Report to Council

CAPSTAN CANADA LINE STATION – TRANSLINK – NO. 3 ROAD AND
CAPSTAN WAY
(January 27, 2021)

Re : Capstan Station – DAP Step 9 : Final Design Report

To: Development Permit Panel
From: Wayne Craig
Director, Development
Date: January 18, 2021
File: 08-4105-10-01/2021-Vol 01
Re: TransLink Capstan Canada Line Station

PUBLIC ART INFRASTRUCTURE - ELECTRICAL

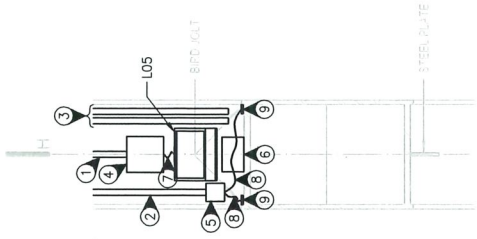
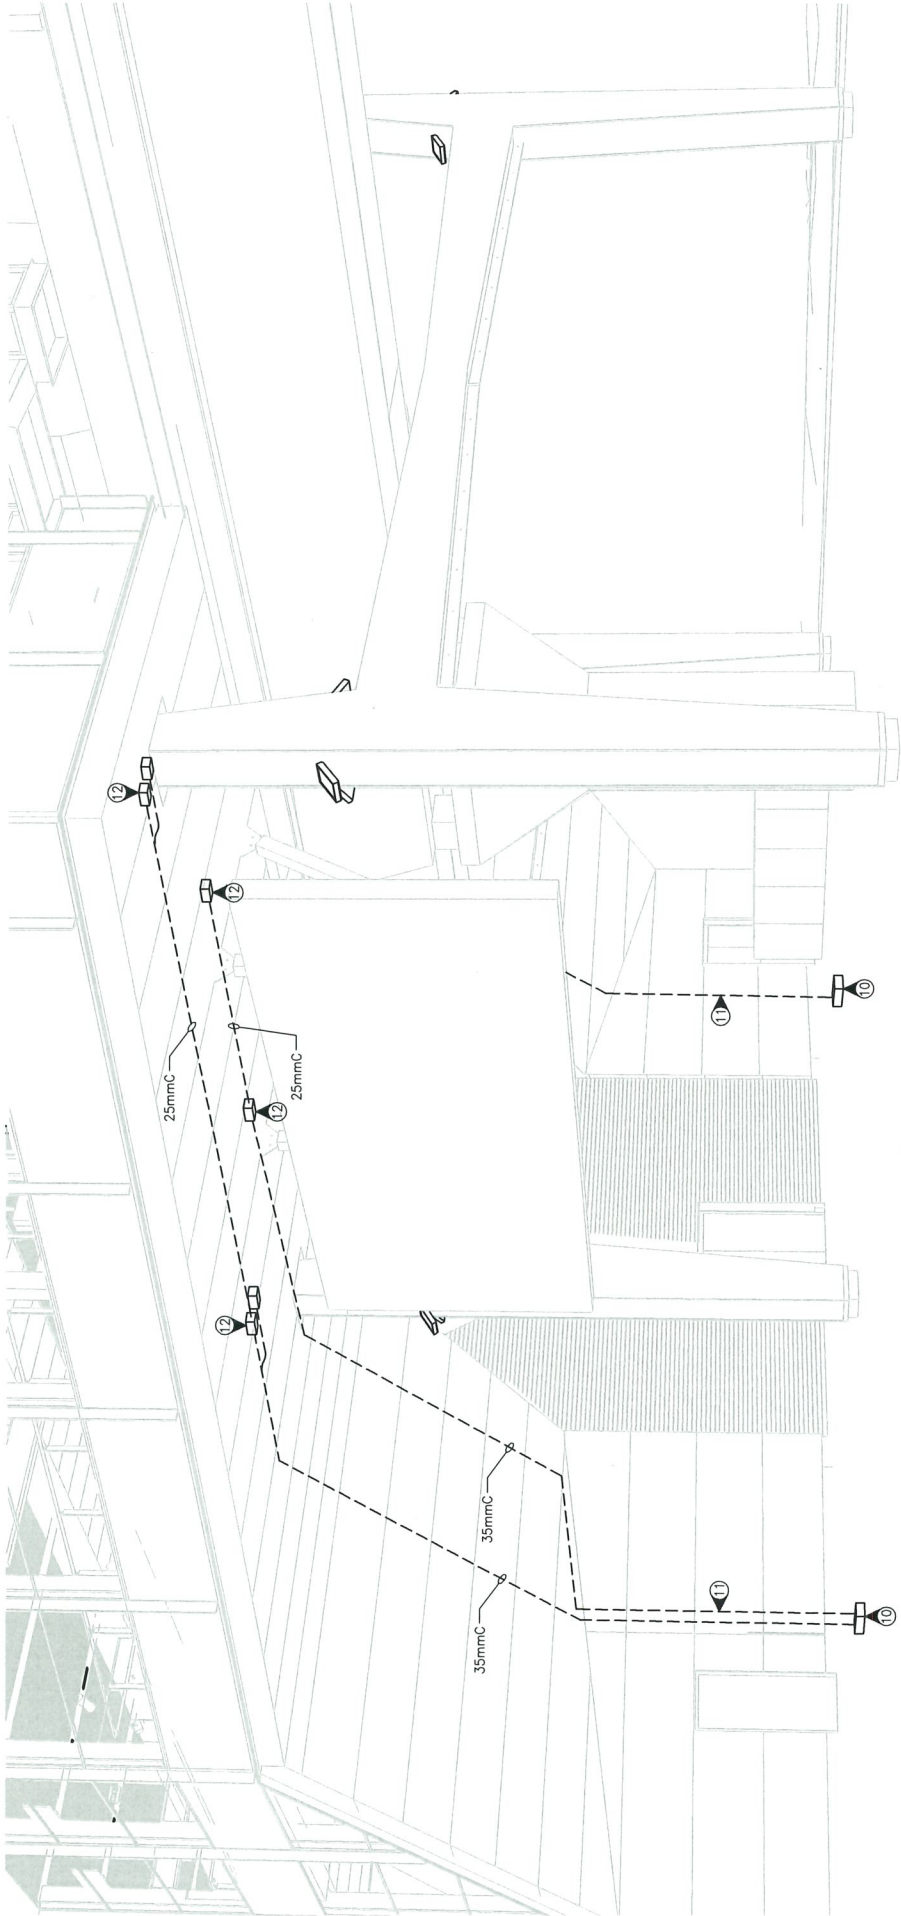
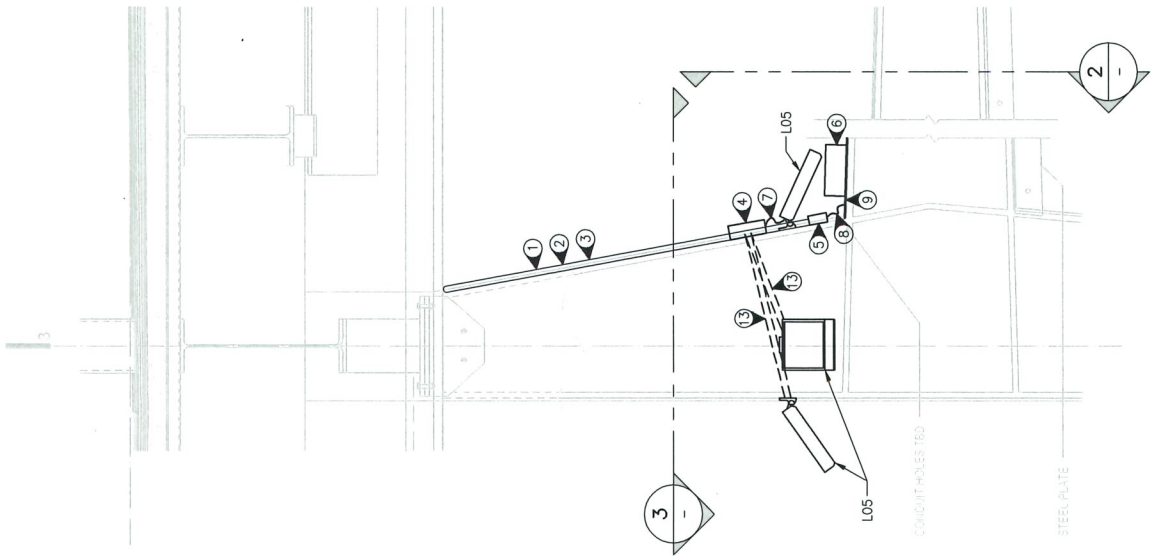
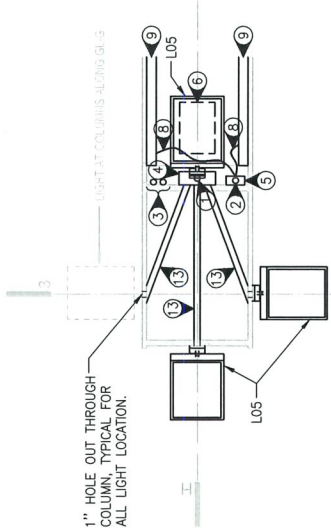
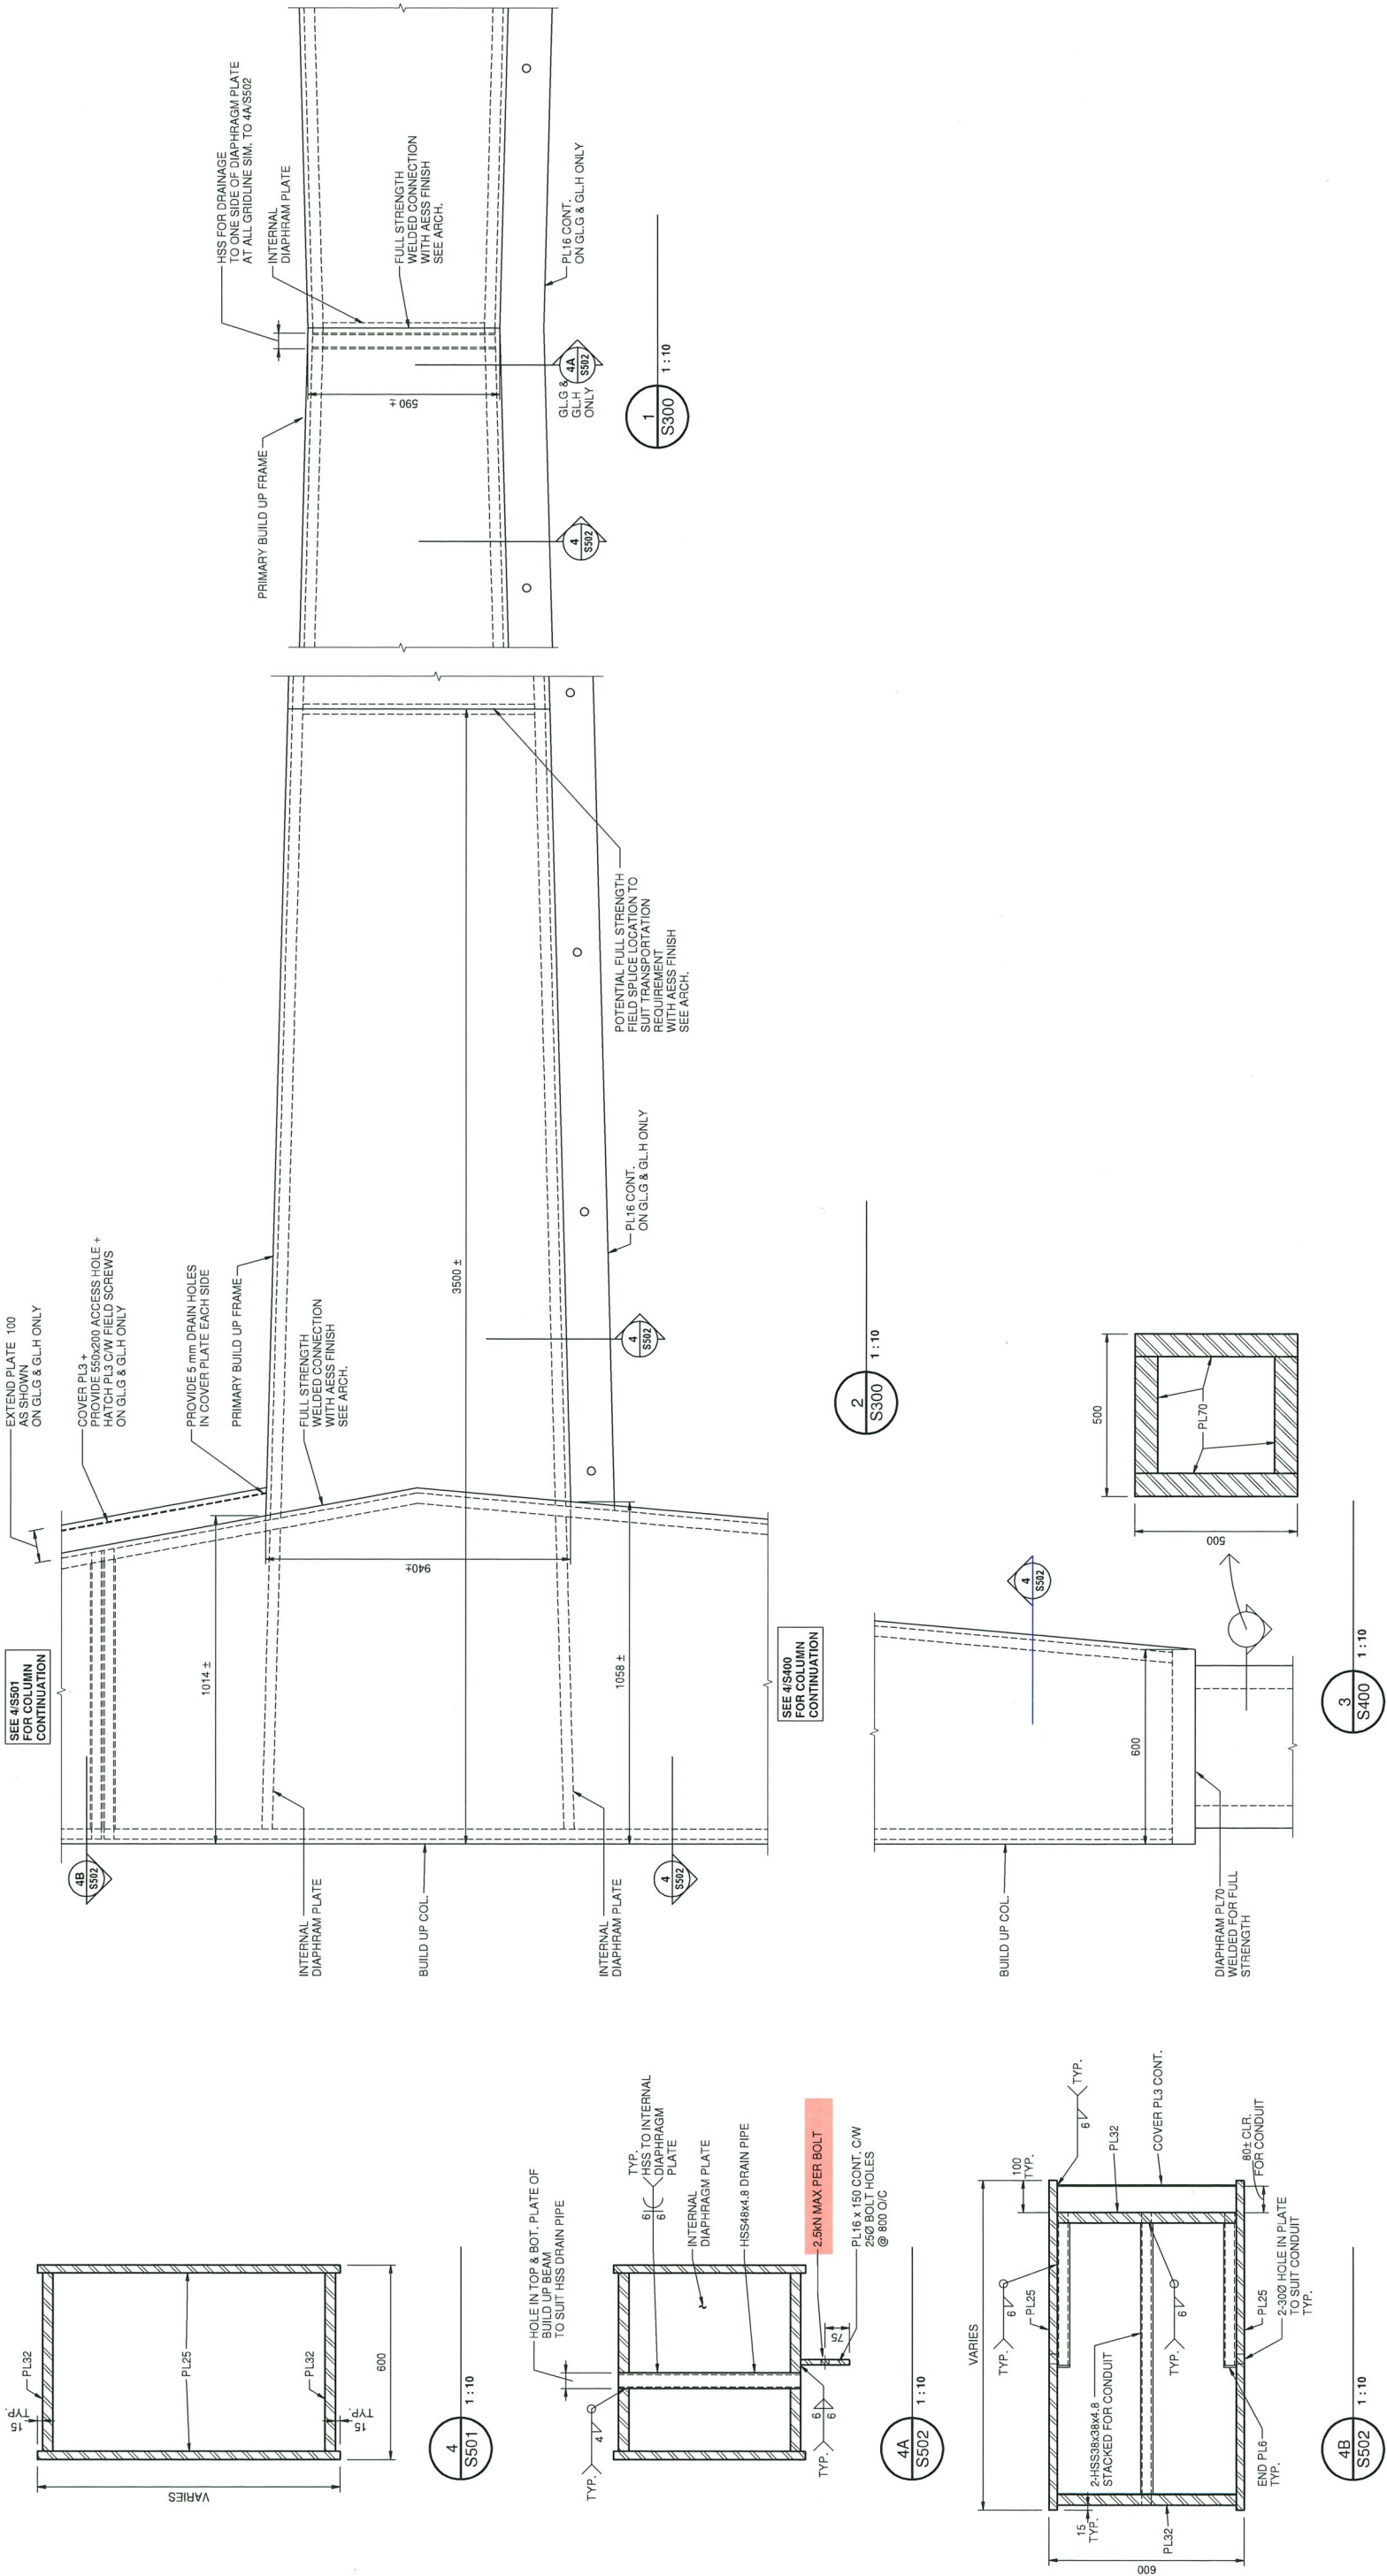
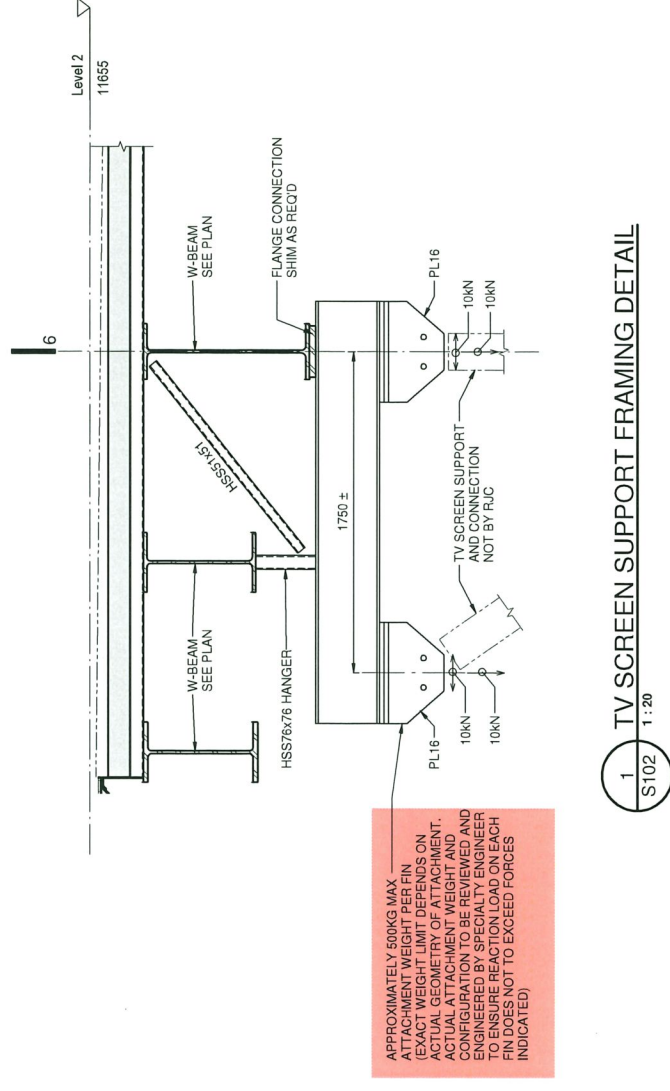
Design development is required to facilitate the City's implementation, at the City's sole cost, of temporary public art and activation programs (e.g. power communications, video monitors, and lighting), together with potential station related enhancements

4. Providing multiple locations for exterior power and data outlets and conduits to stub outs at grade. The City will be providing power and locate supporting controls remote from the station – **refer to Appendix ITEMS 1-5**

5. Facilitating potential lighting, projector, and monitor points for showcasing public art (above grade only) – **refer to Appendix ITEMS 1-5.**
6. Working with City staff to develop an MOU agreement between TransLink and the City of Richmond for administration and implementation of the Public Art on an ongoing basis.
